Subject: New application post - NYM/2021/0100/FL - 17 High View, Eskdaleside, Sleights - Applicant correspondence

Subject: Revised drawings for application NYM/2021/0100/FL

NYM/2021/0100/FL

AMENDED DRAWING OF
SOUTH ELEVATION AND PLAN
SHOWING INTERNAL CHIMNEY,
AND LOWERED STACK.

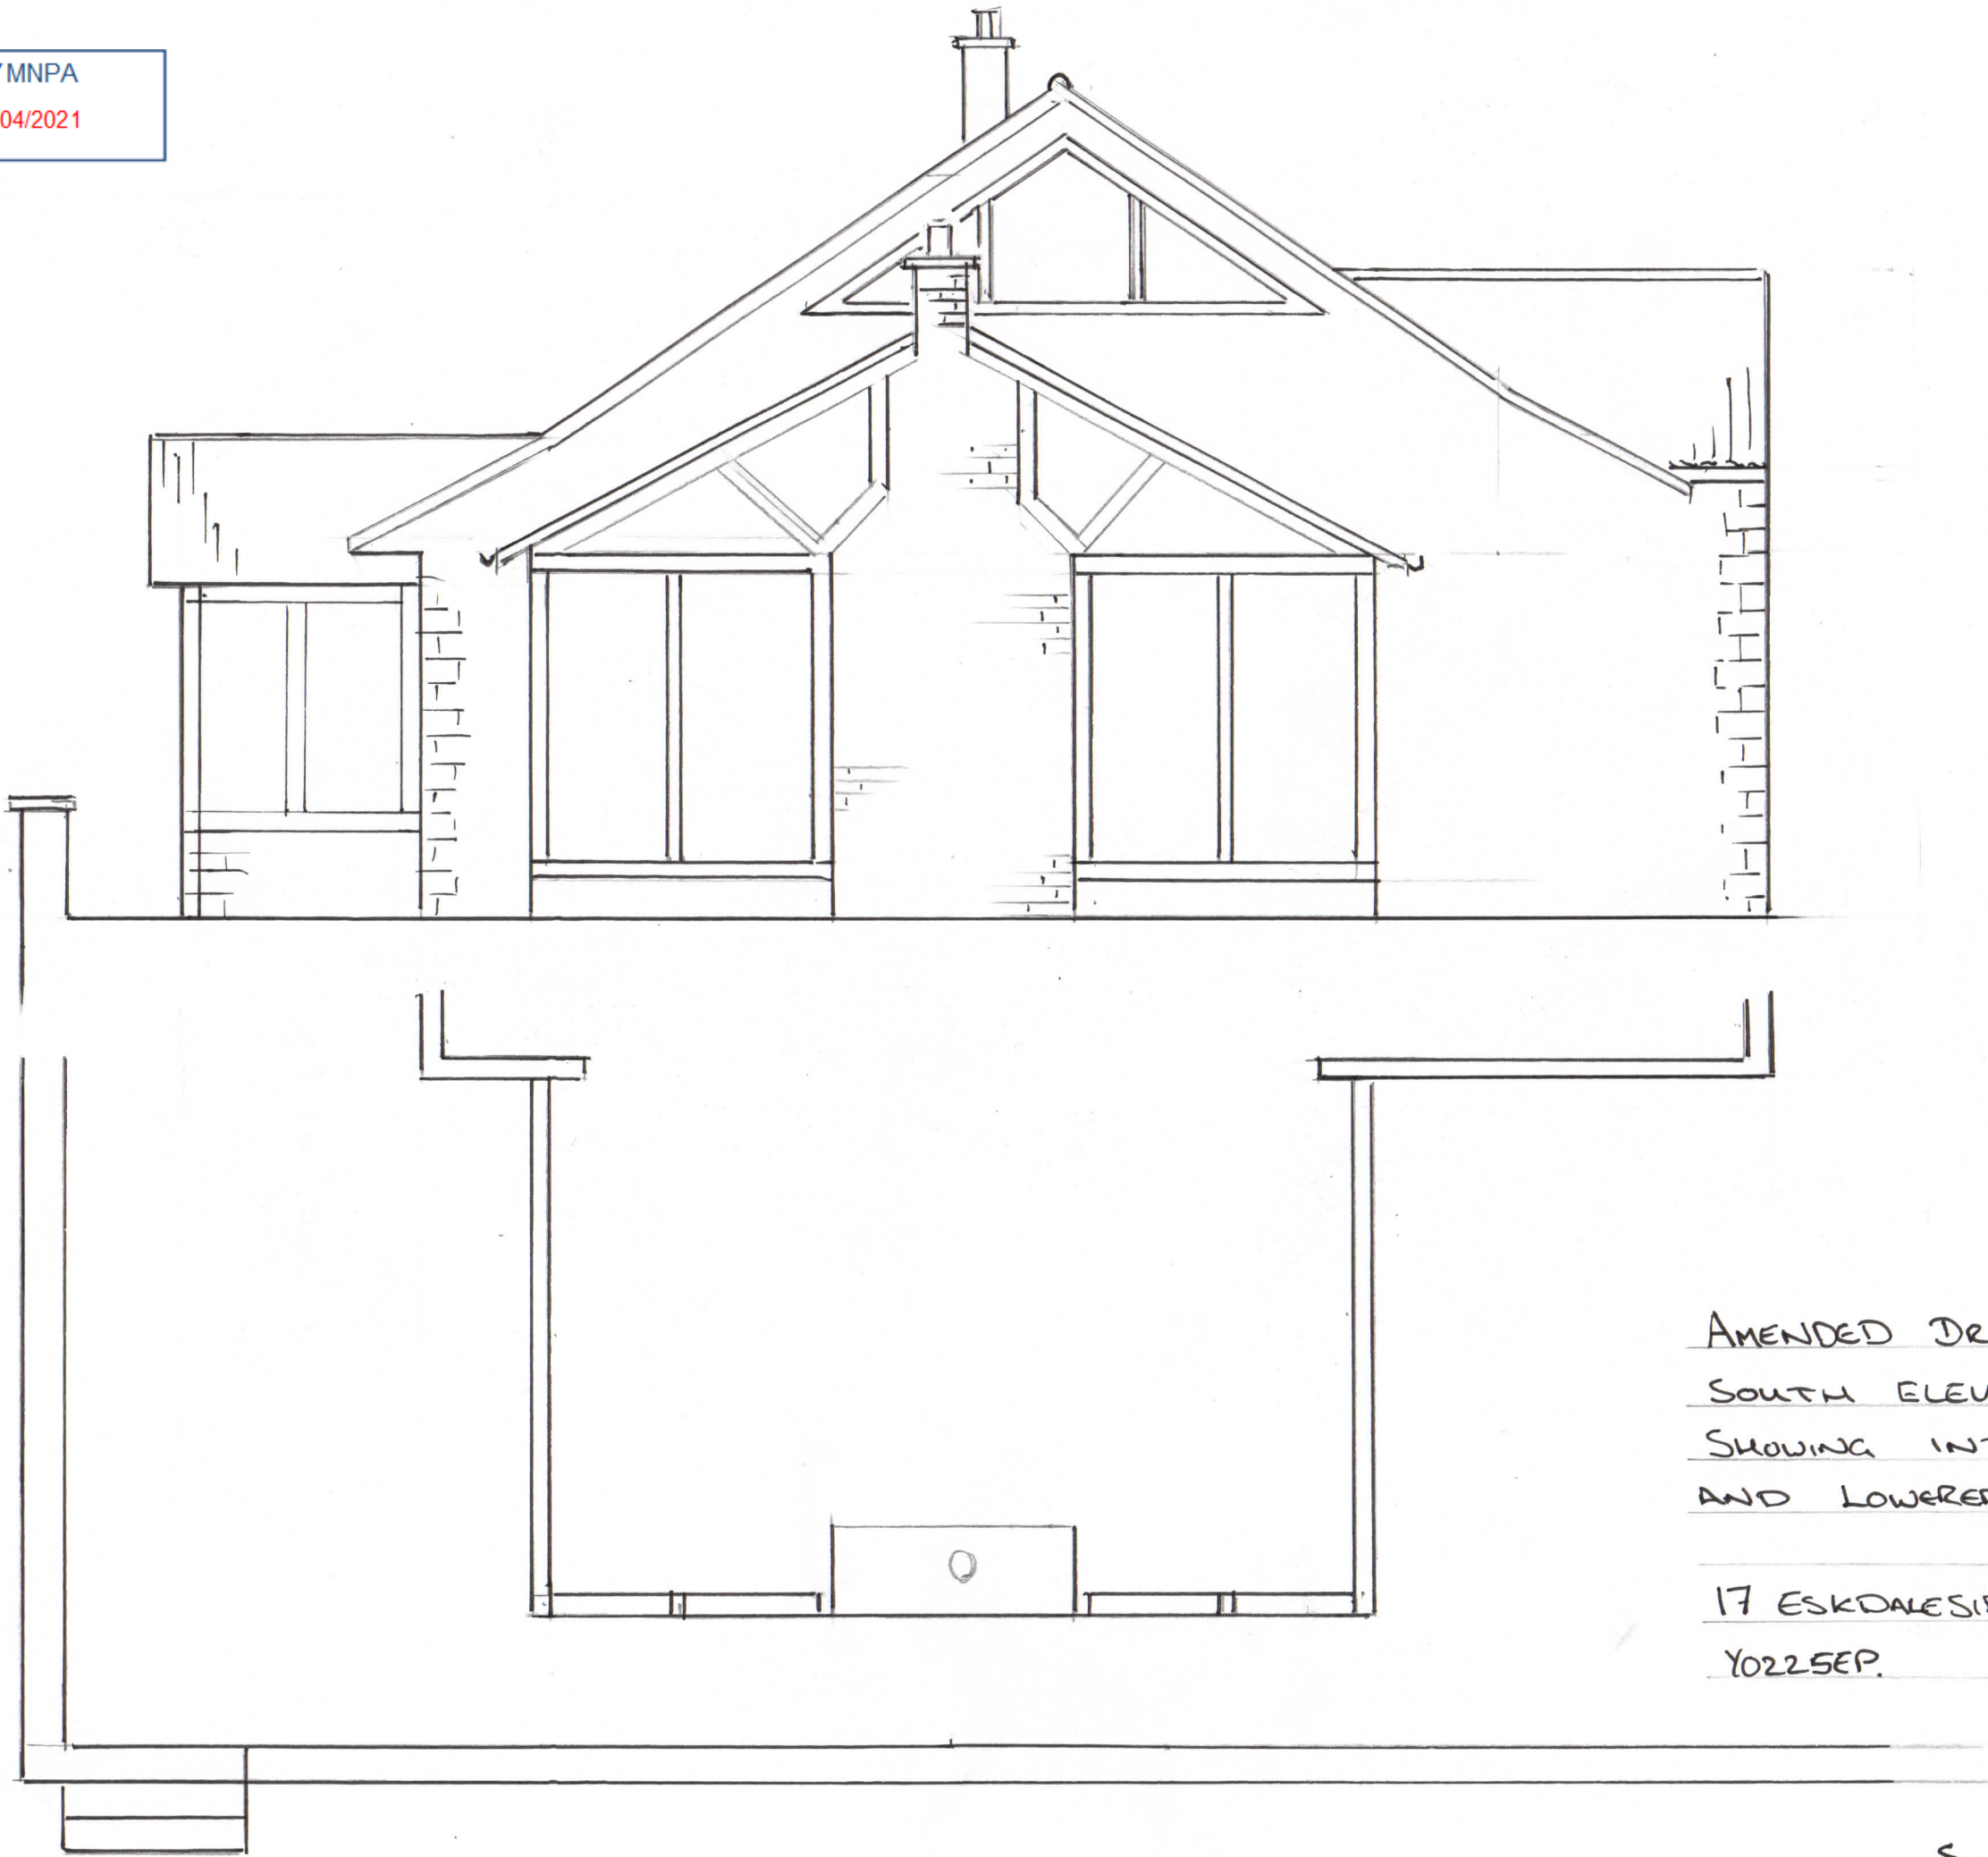
Regarding the chimney on the oak conservatory we have brought the chimney breast internally as advised and have reduced the stack height also.

AMENDED DRAWING OF REDUCED
PORCH.
17 ESKDALESIDE, SLEIGHTS, WHITBY, YOZZEP.

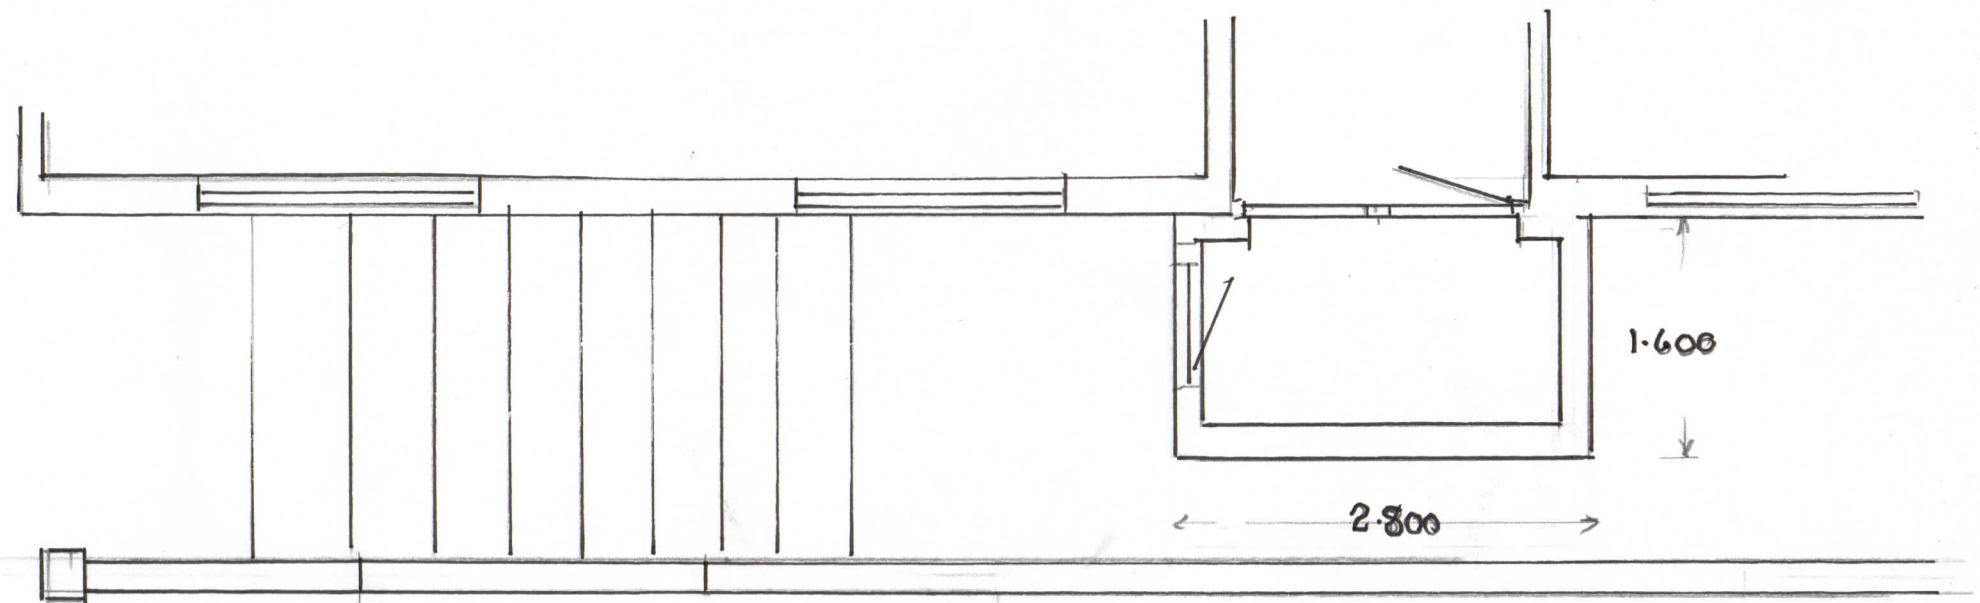
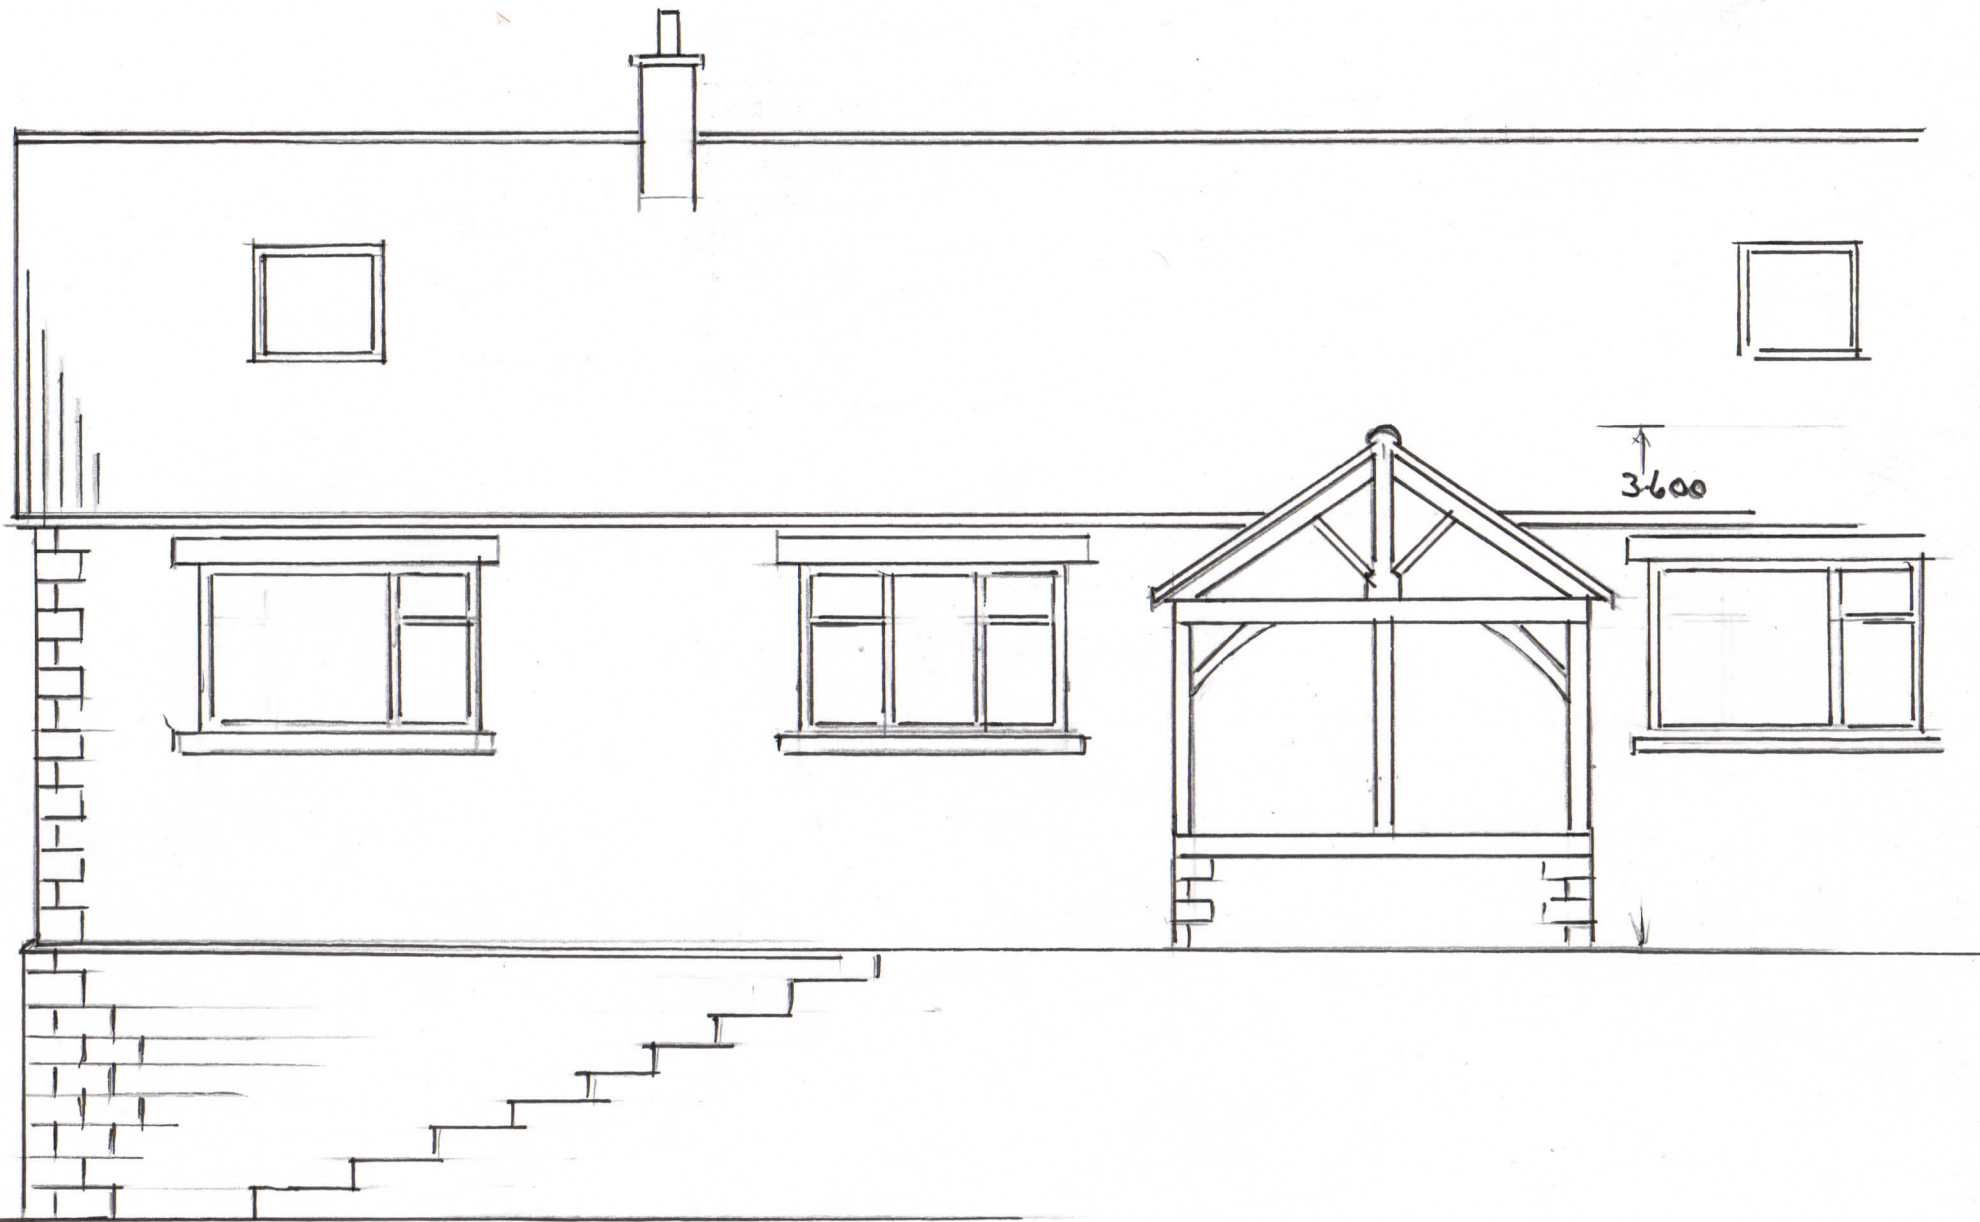
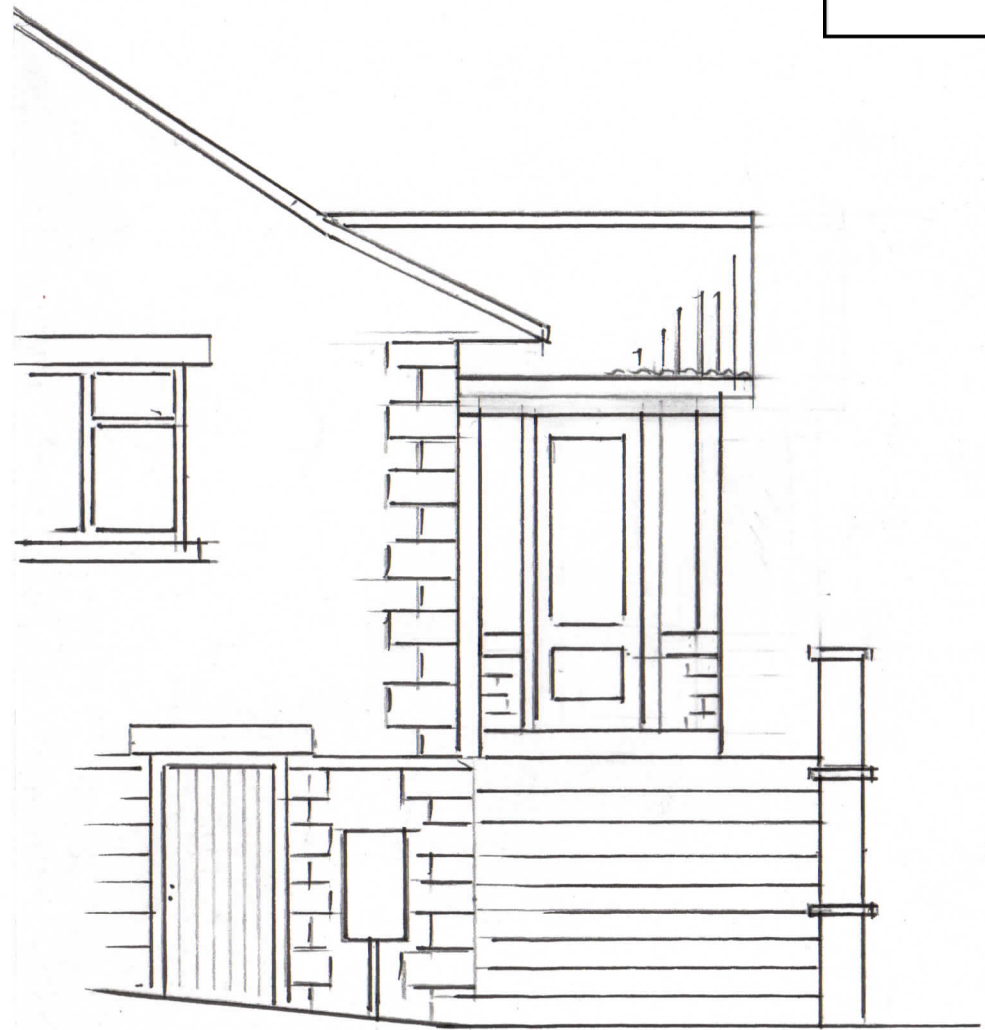
We have reduced the overall size of the porch and we have simplified the roof by removing the apex roof above the door also reducing the height of the porch.
